SERVICE BULLETIN

BRIGGS & STRATTON, LLC

TO:	NOTIFIED CUSTOMERS	CRITICAL CORRECTION - ACTION AND RESPONSE REQUIRED IMMEDIATELY	<input checked="" type="checkbox"/>
BULLETIN NUMBER:	21-0006-NL-GR	ACTION REQUIRED - FIX, NO REPORT	<input type="checkbox"/>
DATE OF NOTICE	3/30/21	IF ENCOUNTERED - CORRECT IF ISSUE IS FOUND	<input checked="" type="checkbox"/>
SUBJECT:	NL-GR SERIES DIESEL UPDATES	INFORMATION ONLY	<input type="checkbox"/>
PRODUCT LINE:	NL-GR SERIES		
MODEL:	DIESEL	AUTHORIZED LABOR CHARGES FOR THIS BULLETIN:	
		.5 HR / \$50 PER UNIT	
SERIAL NUMBERS:	25-000001 - 25-000410	PART NUMBERS REQUIRED TO CORRECT THIS BULLETIN:	
		SEE BULLETIN ITEMS	
EXPIRATION DATE:	4/30/2021		
DESCRIPTION OR SUMMARY OF PROBLEM TO BE CORRECTED:

Item 1: Remove existing tailpipe and exhaust bracket.

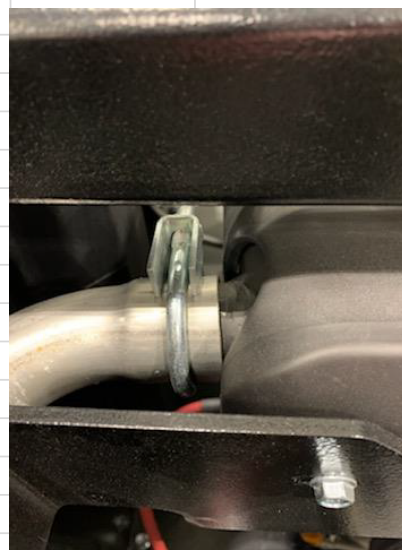
1. The exhaust tail pipe vibrates continuously causing breaks in the tailpipe and bracket. 2. Remove the existing tail pipe and bracket. Replace with updated tailpipe and exhaust bracket.			
CORRECTIONS AND INSTRUCTION:			
See attached brochure for installation instructions #122017			
CONTACT INFORMATION: FOR ADDITIONAL CLARIFICATION OR FURTHER INSTRUCTIONS, PLEASE CONTACT THE FOLLOWING: TECHNICAL SERVICES @ 1(308)995-3431

Locate the tailpipe and remove both clamps and set to the side. Remove current tailpipe and discard. Remove the current tailpipe bracket by loosening 2 M10x8 hex head screws. discard bracket and reinstall screws.

Open rear door and disconnect tail light harness. Then remove the front and back cover that are both attached to the lift bow. Set the doors and all the hardware to the side.
